Re: Florida Power & Light Company
St. Lucie Units 1 and 2, Docket Nos. 50-335, 50-389
Turkey Point Units 3 and 4, Docket Nos. 50-250, 50-251

Response to Request for Additional Information Regarding License Amendment Request for
Common Emergency Plan Consistent with NUREG-0654, Revision 2

Response to Request for Additional Information

**Figure 1-1
FLEX Enhances Defense-in-Depth**

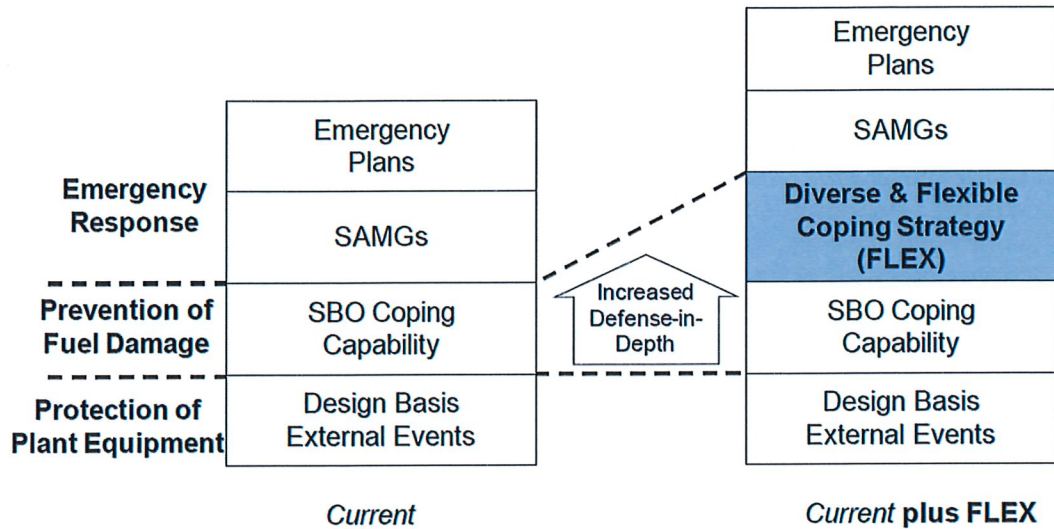
Request: Provide the following clarifications regarding the NextEra FLEX strategy:

Per NEI 12-06, Diverse and Flexible Coping Strategies (FLEX) Implementation Guide, Revision 4, dated December 2016 (endorsed by the NRC in Regulatory Guide 1.226, Flexible Mitigation Strategies for Beyond-Design-Bases Events, Revision 0, Dated June 2019) (Revision 5, dated April 2018 not endorsed), the objective of FLEX is to establish an indefinite coping capability to prevent damage to the fuel in the reactor and spent fuel pools and to maintain the containment function by using plant equipment and FLEX equipment. The FLEX strategies are focused on maintaining or restoring key plant safety functions and are not tied to any specific damage state or mechanistic assessment of external events. A safety function-based approach is in keeping with the symptom-based approach taken to plant emergency operating procedures (EOPs) and facilitates the utilization of the FLEX strategies in support of the operating and emergency response network of procedures and guidance. Flex strategies will be used to supplement (not replace) the previously existing procedure structure that establish command and control of events (e.g., AOP, EOP, SAMG, etc.).

Implementation of the FLEX equipment, procedures and processes significantly extends the timeline even with failed safety related equipment. This time extension is listed in NEI 12-6 and validated/evaluated to 6 hours. NEI 12-06 Figure 1-1 depicts the time extension.
